**Dietrich Elevated Storage Tank  
Solicitation Number: CO-00274  
Job No.: 16-6003**

**ADDENDUM 2  
August 4, 2021**

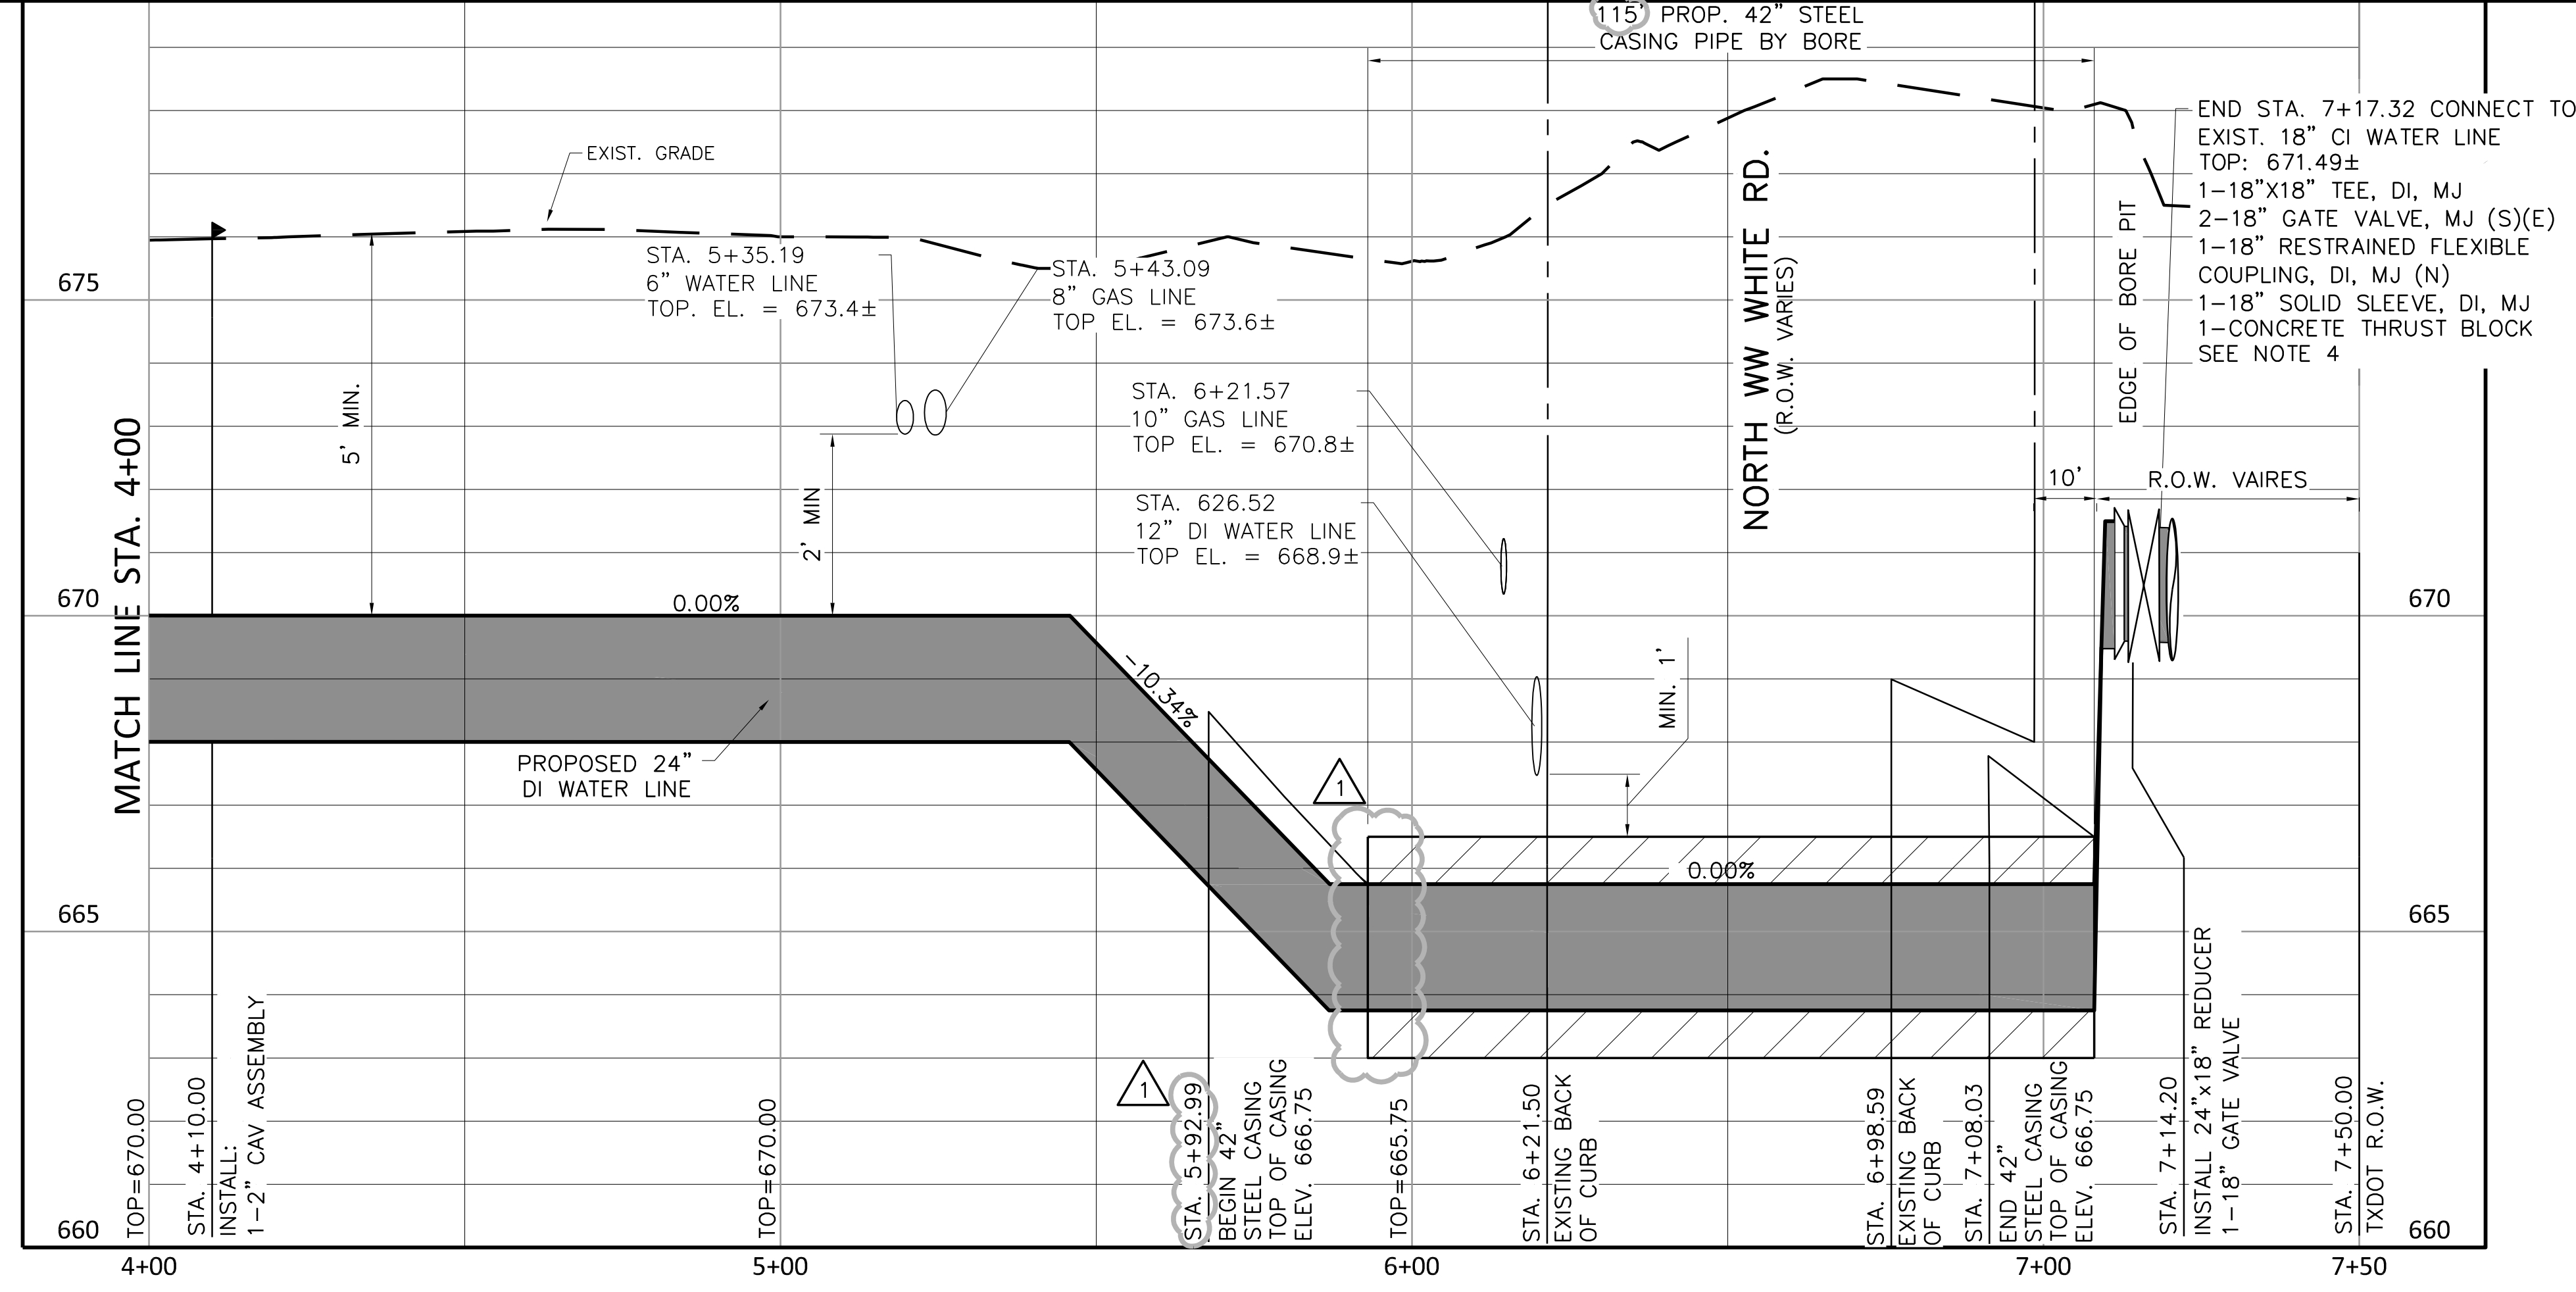
31. Drawing W-2 there are existing power poles at the location of the 15x35 bore pit. Will the utility company relocate, or temporality brace the existing poles to allow us to excavate?

*Per note 5. on sheet W-2, Contractor is responsible for protecting and supporting utilities impacted by the bore pits.*

Sheet T-1

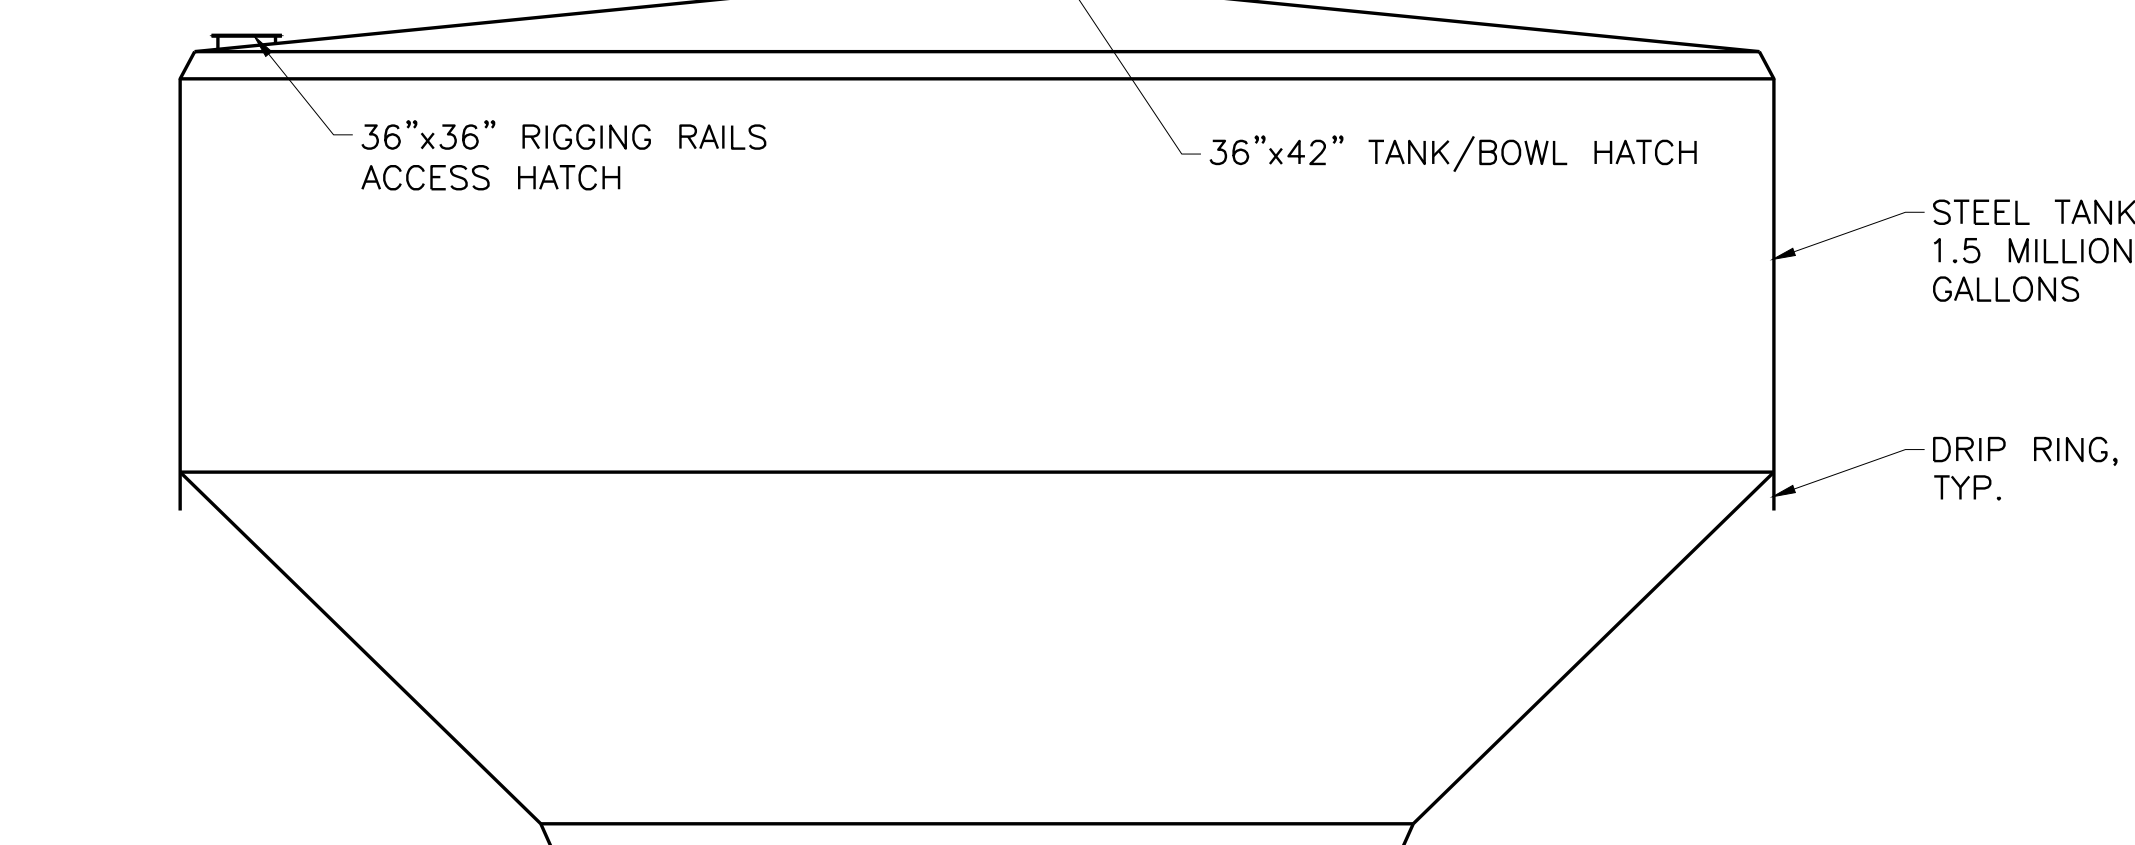
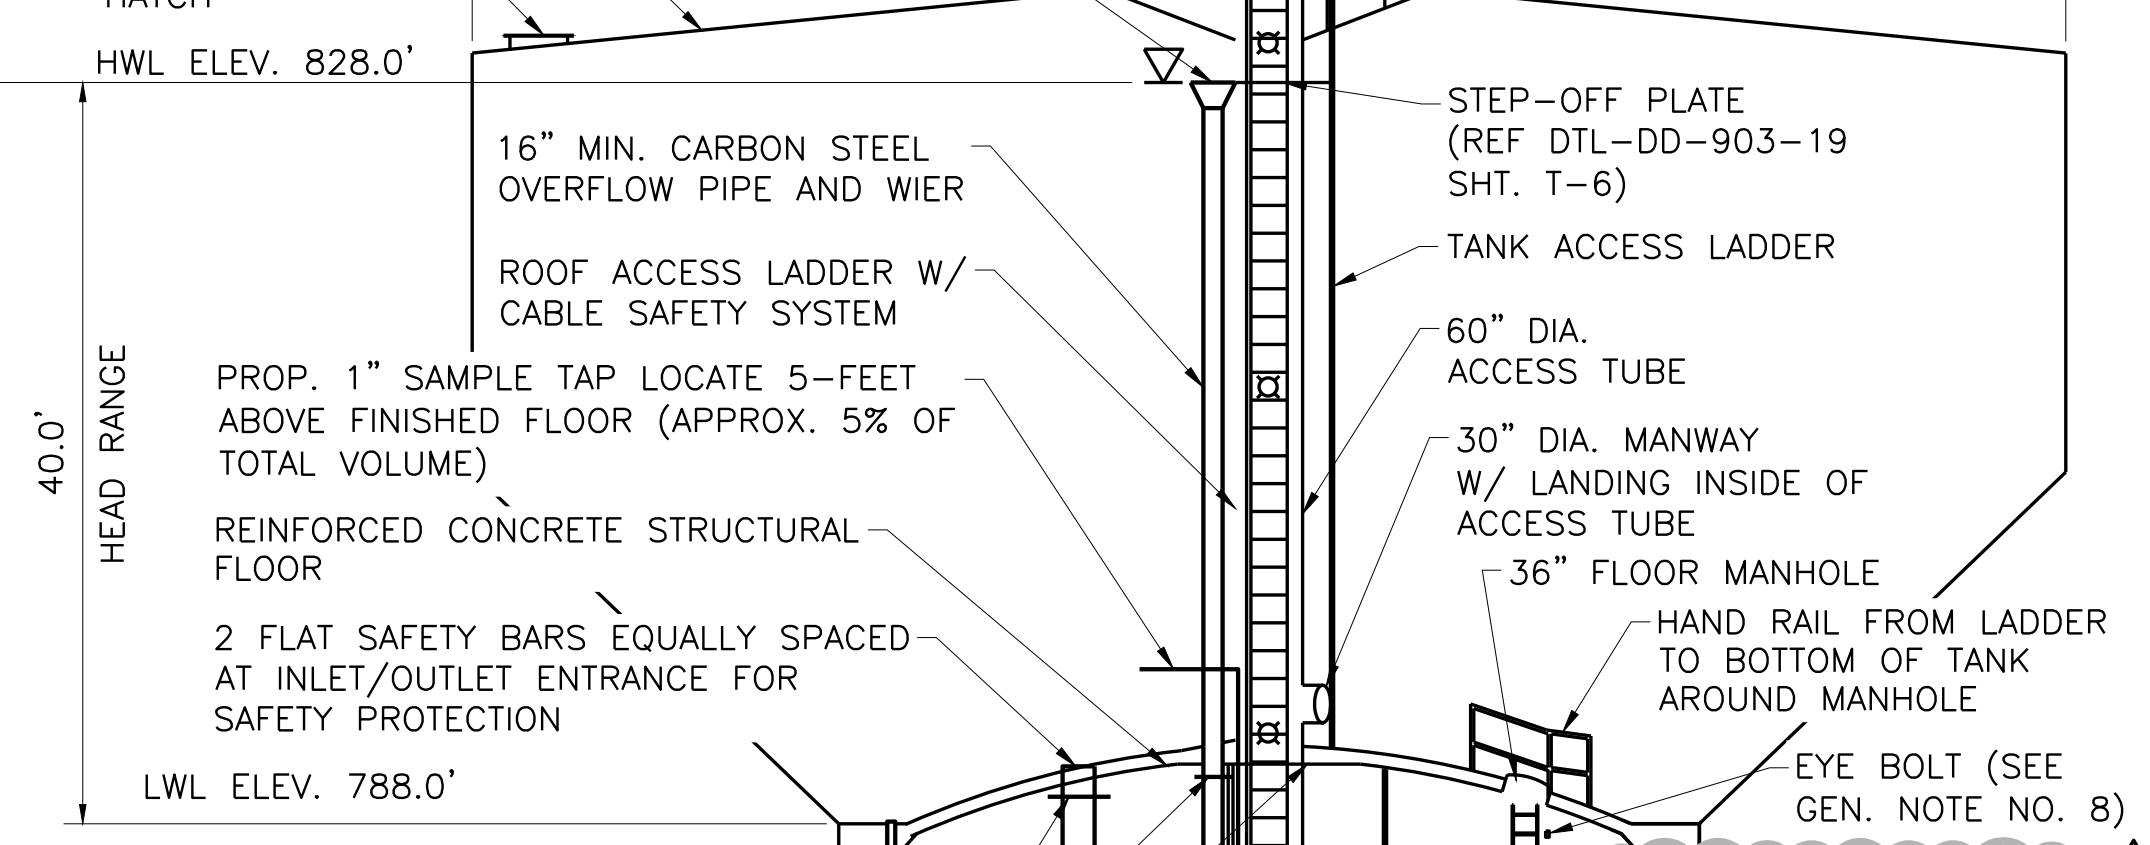
25. Drawing T-1 specifies the access tube extending below the tank floor down to the upper platform. This is another manufacturers standard and is used to support the upper platform. Our standard construction detail does not permit the access tube to be taken past the tank floor and we do not require the access tube to support our upper platform. Either tank manufacturers standard will provide continuous ladder access from the upper platform to the tank roof. Please confirm that individual manufacturers standard details will be acceptable.

26. Drawing T-1 specifies a drip pan located under the access tube (typically attached to the underside the walkway) to collect any condensate dripping from the access tube. This detail has been improved and is no longer done; we suggest the following clarification, which is current industry standard. *The access tube shall incorporate a 2" x 2" channel to collect condensation that may form on the interior surface of the access tube. A flexible 3/2" PVC hose complete with backflow preventer shall drain the channel to the overflow pipe.*

28. Drawing T-1 shows an upper return at the intersection of the tank side wall and the tank roof. It is not described or dimensioned in Section 13415. Is an upper return required? If required, we suggest the industry standard dimension of 1'-6" H / 2'-6" V.

29. Drawing T-1 Interior Elevation shows a 6" floor slab, Section 13415 describes an 8" floor slab. Please clarify.

*An upper return is required as shown in design plans and shall be dimensioned per industry standards.*

*Detail 2/T-1 indicates 6" minimum floor slab, if a thicker slab is required based on the manufacturer's design, then provide a thicker slab.*
